## SUMMARY REPORT

**Client:** New Construction Buyer  
**Inspection Address:** Camelot Homes, Glendale , Arizona  
**Inspection Date:** 1/3/2005  
**Inspected by:** Sean Preston

## **CONFIDENTIAL INSPECTION REPORT**

Figure Set - 1 There are numerous hold downs not fastened at the south wall

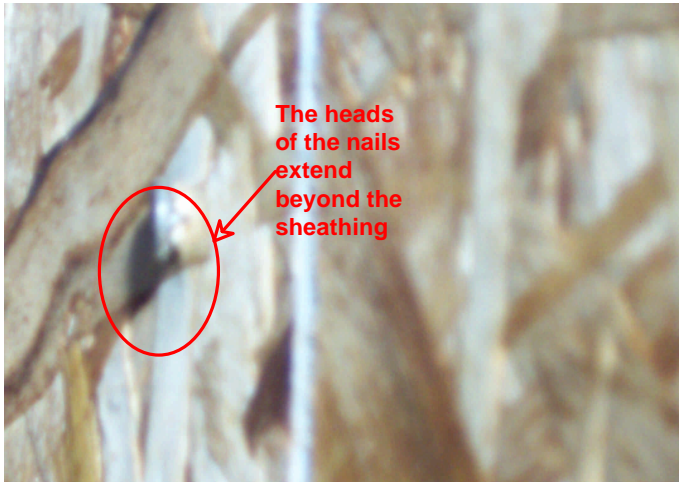
- 1.1 - At the south wall a number of the hold downs are not fastened to the foundation. Recommend proper fastening per engineering specifications.  
*See Attached Picture(s) - Figure Set 1*

1.3 - At the south wall a number of the hold downs are not fastened to the foundation. Recommend proper fastening per engineering specifications.

Figure Set - 4 The fastening of the sheathing at the stairwell wall is not proper

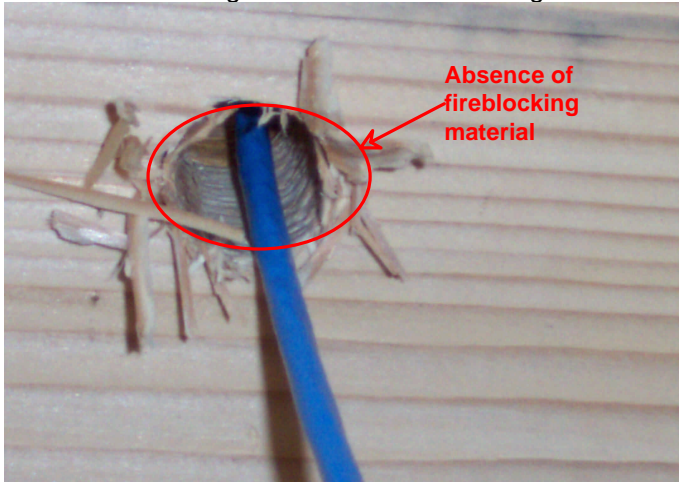
- 1.4 - The fastening of the sheathing at the stairwall wall is not proper, Greater than 20% of the nails are not properly driven. Proper fastening technique is important as this shear wall contributes to the structural integrity of the home.

2000 IBC 2304.9.2 Sheathing nails or other approved sheathing connectors shall be driven so that their head or crown is flush with the surface of the sheathing.

The heads  
of the nails  
extend  
beyond the  
sheathing

1.10 - The fastening of the sheathing at the stairwall wall is not proper, Greater than 20% of the nails are not properly driven. Proper fastening technique is important as this shear wall contributes to the structural integrity of the home.

Figure Set - 7 Additional fasteners required at strapping adjacent to bearing beam

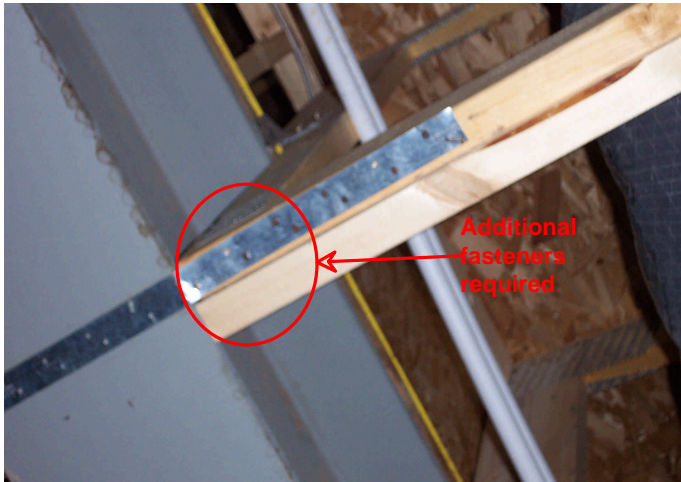
- 1.7 - At the bearing beam, the strapping connecting the trusses on either side requires additional fasteners. Each available hole within the straps require fasteners. Recommend addition of specified fasteners.  
*See Attached Picture(s) - Figure Set 7*

1.17 - At the bearing beam, the strapping connecting the trusses on either side requires additional fasteners. Each available hole within the straps require fasteners. Recommend addition of specified fasteners.

Figure Set - 9 The window flashing at various locations is not properly installed

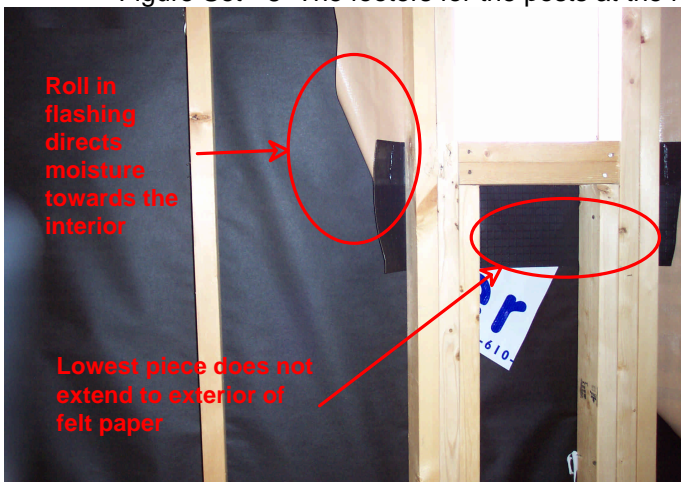
- 2.2 - The window flashings at the following locations is not properly installed:  
Room at North East corner of home  
Master Bedroom closet  
Stairwell - Presence of unattached flashing, confirm proper flashing at all windows

The flashing is to be installed in a manner that all laps shed water, with the lower level overlapped by the upper levels and the lower level terminating on the exterior side of the felt paper.  
*See Attached Picture(s) - Figure Set 9*

- 2.6 - The window flashings at the following locations is not properly installed:
  - Room at North East corner of home
  - Master Bedroom closet
  - Stairwell - Presence of unattached flashing, confirm proper flashing at all windows

Figure Set - 10 A broken truss was located at the second story East side at the North side of the house

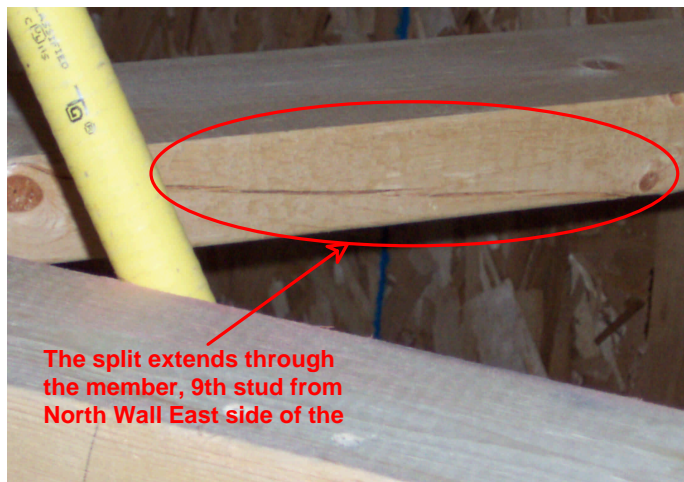
- 3.1 - A broken truss was located at the second story East side at the North side of the house. Counting back from the North wall towards the master bedroom closet it is the 9th truss. The web at the East side of the truss is beginning to split. Recommend repair as prescribed by an engineer.  
*See Attached Picture(s) - Figure Set 10*

3.1 - A broken truss was located at the second story East side at the North side of the house. Counting back from the North wall towards the master bedroom closet it is the 9th truss. The web at the East side of the truss is beginning to split. Recommend repair as prescribed by an engineer.

Figure Set - 12 The secondary condensate line does not extend to the exterior

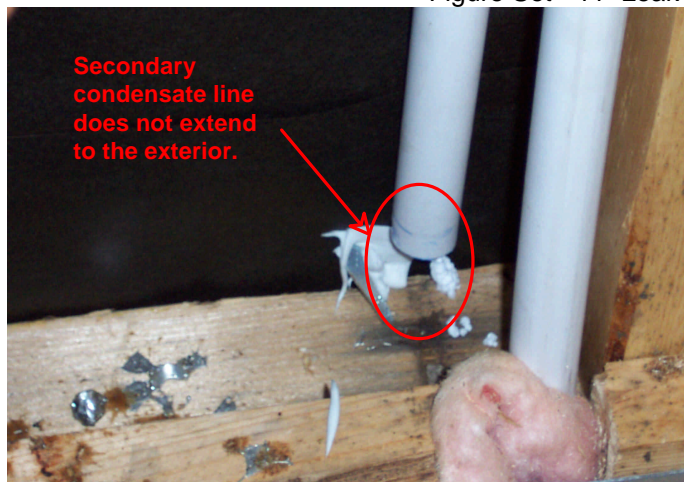
- 5.1 - The secondary condensate line for the HVAC system mounted at the East side of the home does not extend to the exterior. The condensate line terminates within the master bathroom. Recommend extending the condensate line to the exterior.

M1411.3 Condensate disposal. Condensate from all cooling coils or evaporators shall be conveyed from the drain pan outlet to an approved place of disposal. Condensate shall not discharge into a street, alley or other areas so as to cause a nuisance.  
*See Attached Picture(s) - Figure Set 12*

5.4 - The secondary condensate line for the HVAC system mounted at the East side of the home does not extend to the exterior. The condensate line terminates within the master bathroom. Recommend extending the condensate line to the exterior.

Figure Set - 13 Improper clearance to combustible materials at hot water heater flue

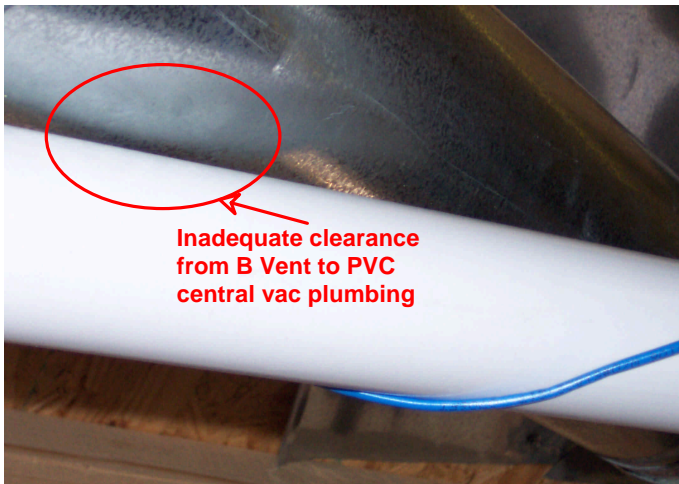
5.2 - The flue for the hot water heater appears to be positioned too close to the PVC piping for the central vacuum system. The clearance to combustibles for type B venting is 1". Recommend increasing the clearance.

5.9 - The flue for the hot water heater appears to be positioned too close to the PVC piping for the central vacuum system. The clearance to combustibles for type B venting is 1". Recommend increasing the clearance.

Figure Set - 15 The structured wiring is in contact with the gusset plate

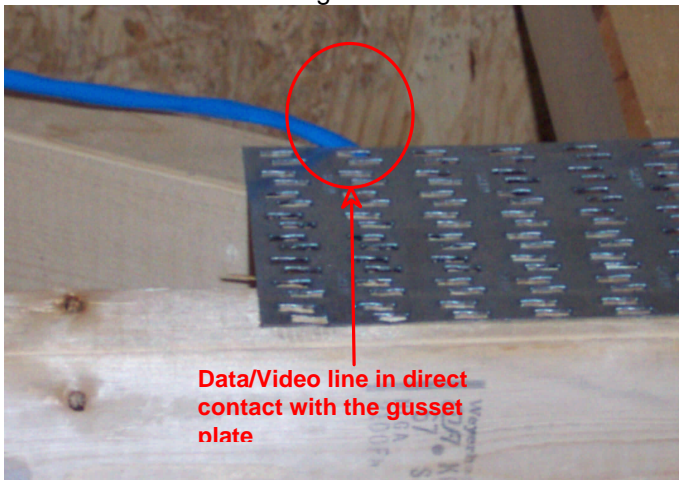
6.1 - At the lower level bedroom, a data/video cable is run against the gusset plate. Recommend moving the cable to protect from damage.

6.1 - At the lower level bedroom, a data/video cable is run against the gusset plate. Recommend moving the cable to protect from damage.

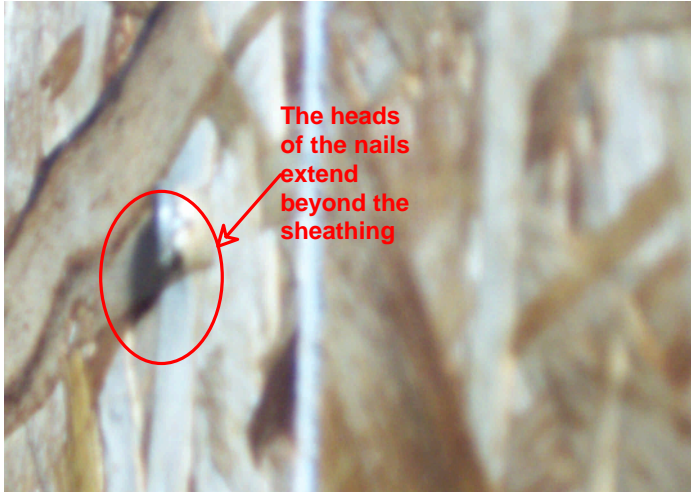
1.9 - The strapping at the header in the lower level bedroom is not properly fastened. Recommend installation of additional approved fasteners.

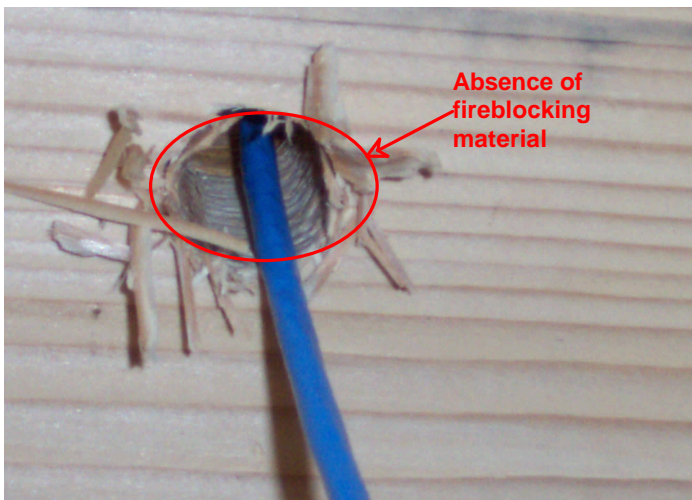
1.13 - There are numerous locations where the required firestopping materials is not present. There are too many locations to practically list, In general, the penetrations that do not meet the firestopping requirements include the gas line penetrations, the data/video cabling penetrations. Recommend installation of firestopping materials at locations mentioned as well as any other locations that are not noted but required.

602.8 Fireblocking required. Fireblocking shall be provided to cut off all concealed draft openings (both

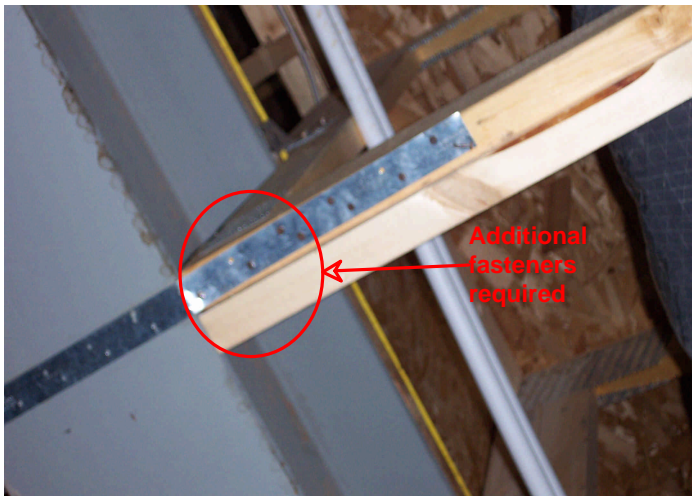
- 1.16 - The column supporting the bearing beam is not properly fastened to the foundation. At the west side of the beam, the column is fastened with only one bolt. Recommend repair per engineering specifications.
